**TORRES SURVEYING**  
1570 BRIDGE BLVD. SW  
ALBUQUERQUE, NEW MEXICO 87105  
243-4854 ~~243-4854~~

RE: Grading and Drainage Plan for expanded paved parking area for the existing EAST OCEAN RESTAURANT facilities located at 3601 Carlisle Blvd. N.E., (approved drainage plan for said site dated September 16, 1994).

A PROPOSED DRAINAGE  
 FOR  
 A JOINT USE PARKING AREA  
 "EAST OCEAN CHINESE & SEAFOOD"  
 ALBUQUERQUE, NEW MEXICO  
 SEPTEMBER, 1994

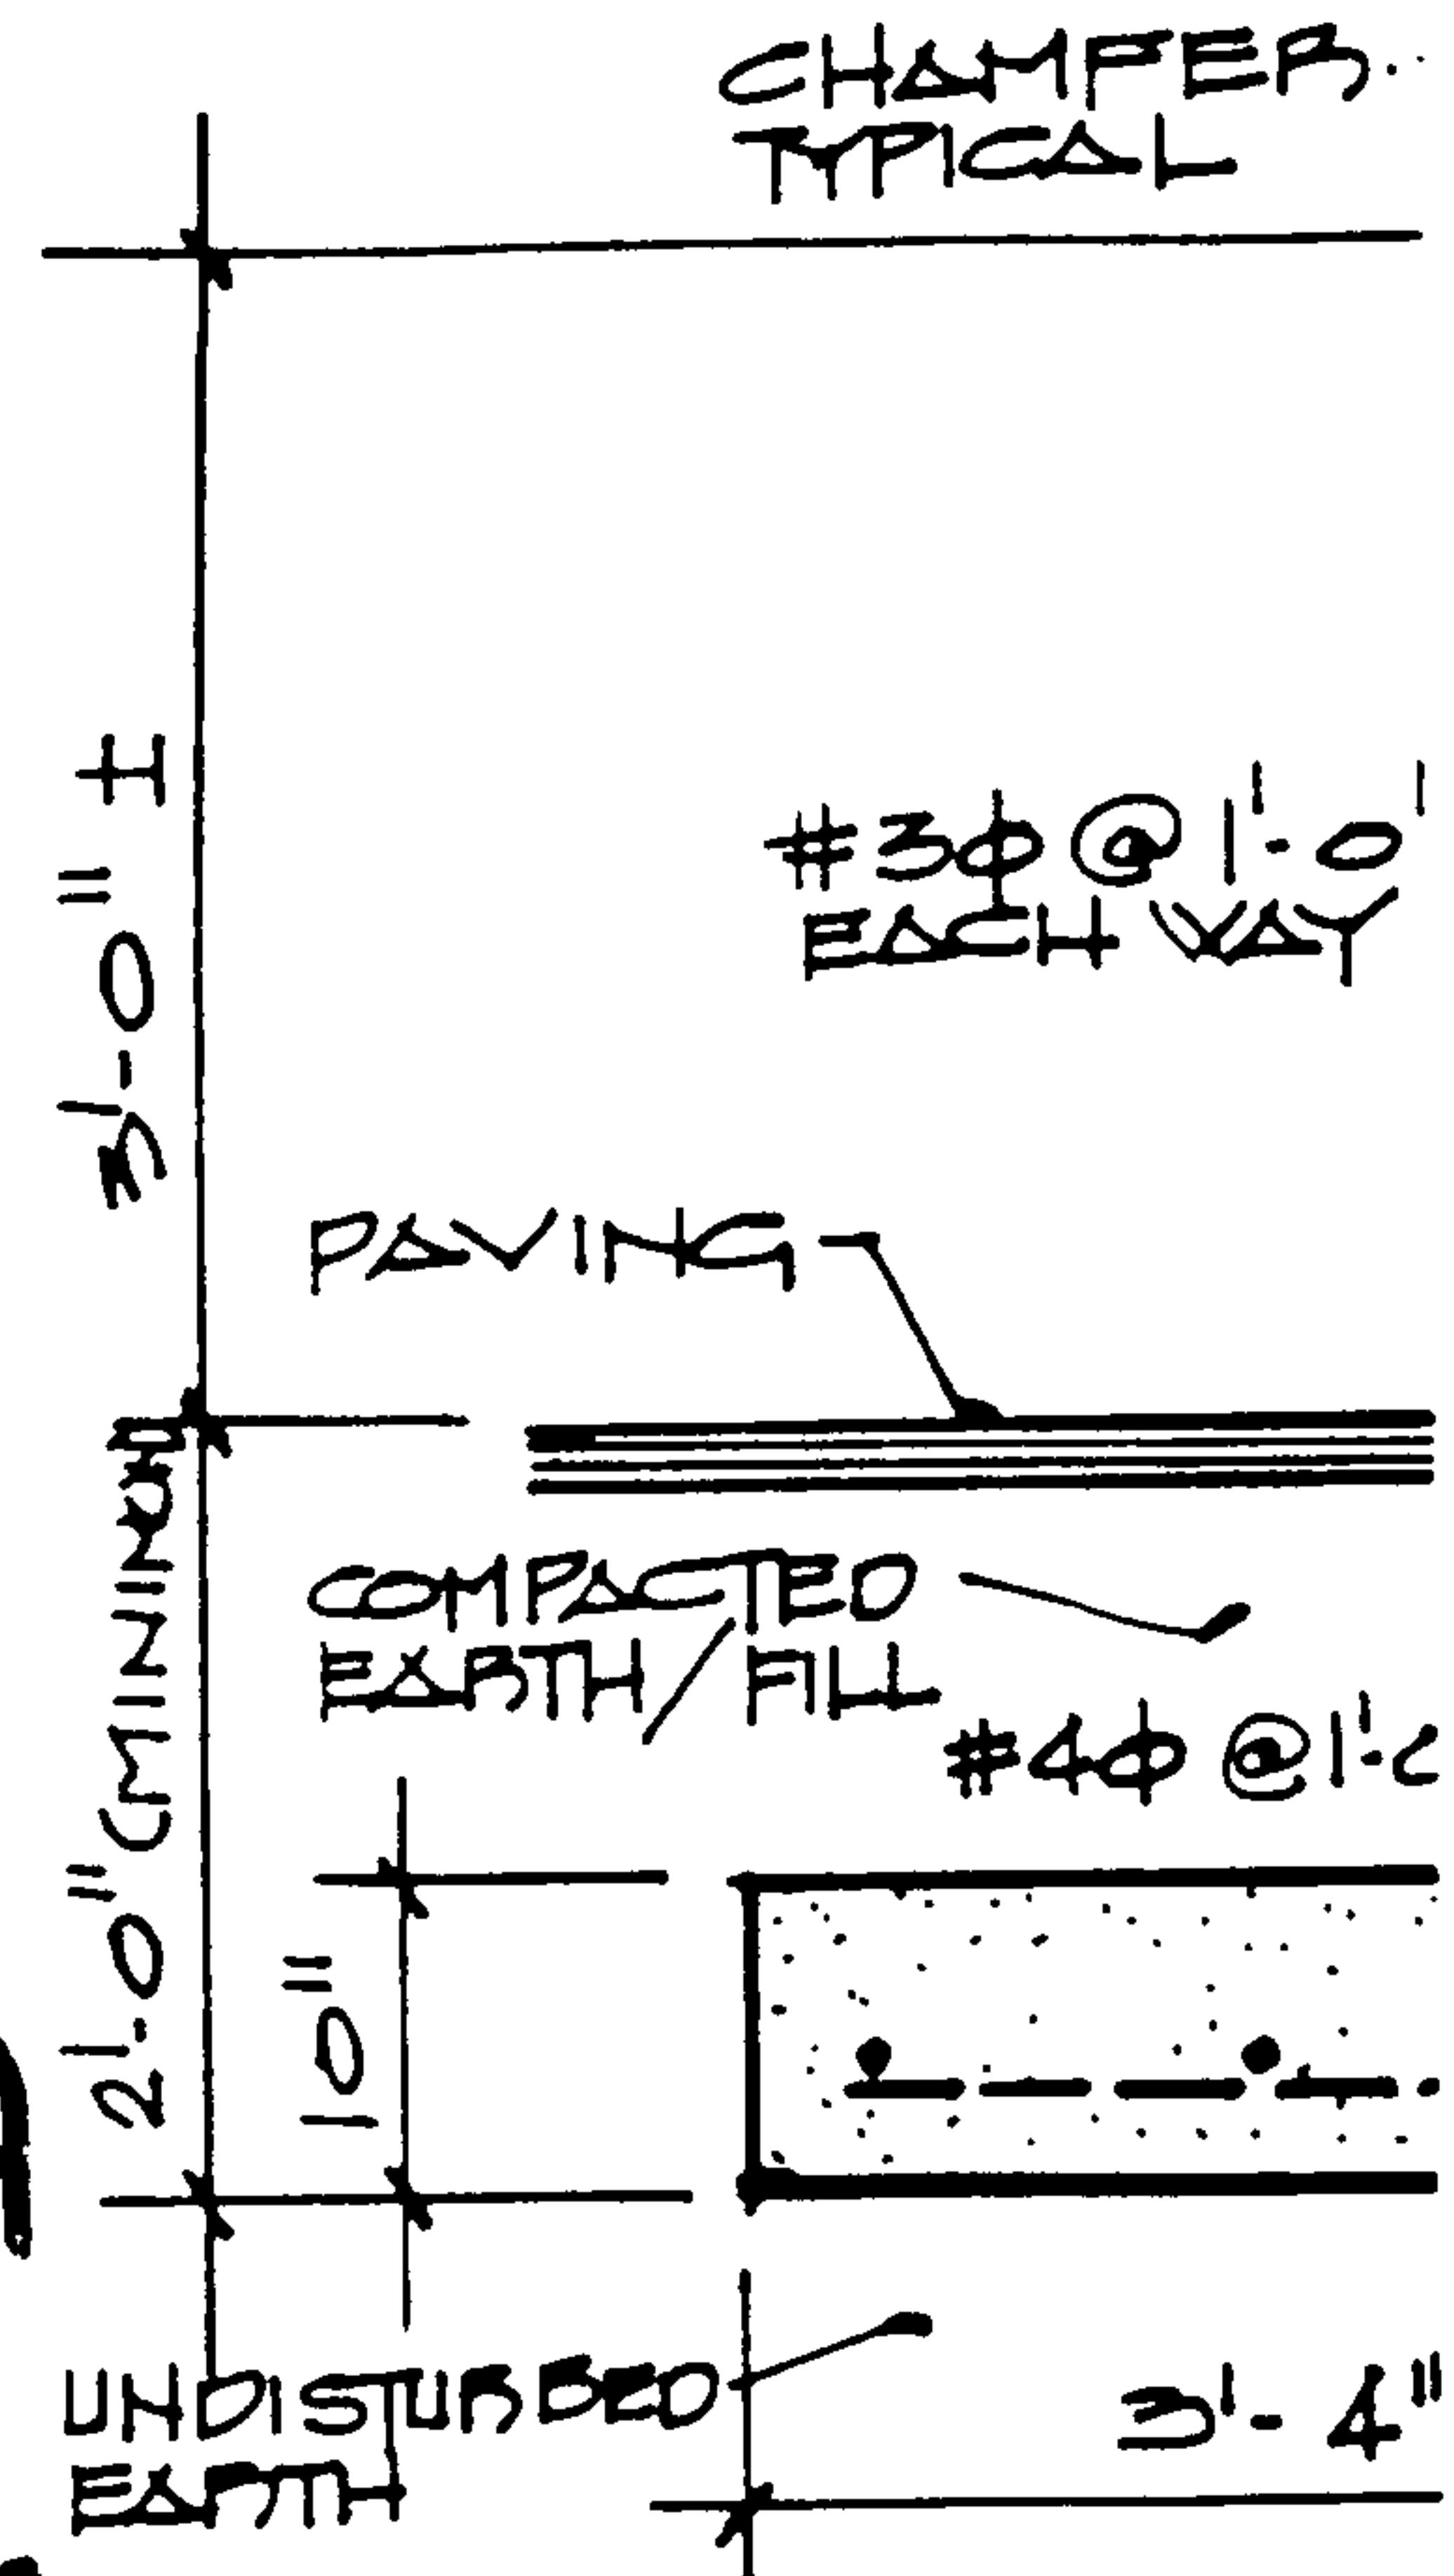
Our field inspection and verification of the existing grades found that surface flows are not outletting through the designed and existing sidewalk culvert located at the approximate Northeast corner of said site, (reference attached copy of plan that shows the existing elevations in red in comparison to the designed grades); this verification shows that the new paved parking area was not constructed in substantial compliance to the designed grades shown on the aforementioned approved Grading and Drainage Plan.

NOTE: ELEVATIONS  
 SHOWN IN "RED"  
 WERE FIELD  
 VERIFIED BY  
 TORRES SURVEY  
 CO. JULY 25, 1996
